A N N O U N C I N G T H E N E W

HS35R

THE MOST RUGGED HOLLOW SHAFT ENCODER

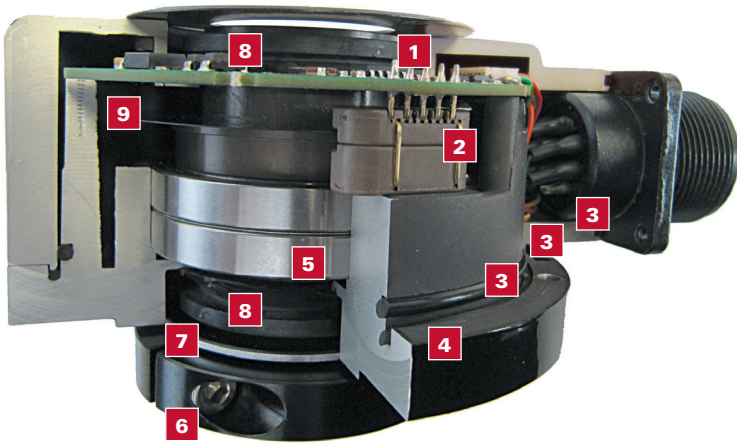
The new HS35R incorporates numerous design upgrades to increase reliability and maximize equipment uptime.

- 1** Fewer PCB Components
- 2** Wide Gap Phased Array Sensor Module
- 3** Multiple O-Ring Seals
- 4** Powder Coat Over Hard Anodizing
- 5** Larger Mechanically-Held Bearings
- 6** Dual Split Clamp
- 7** Protective Seal Plate
- 8** Dual V-Seals
- 9** Non-Glass Disk
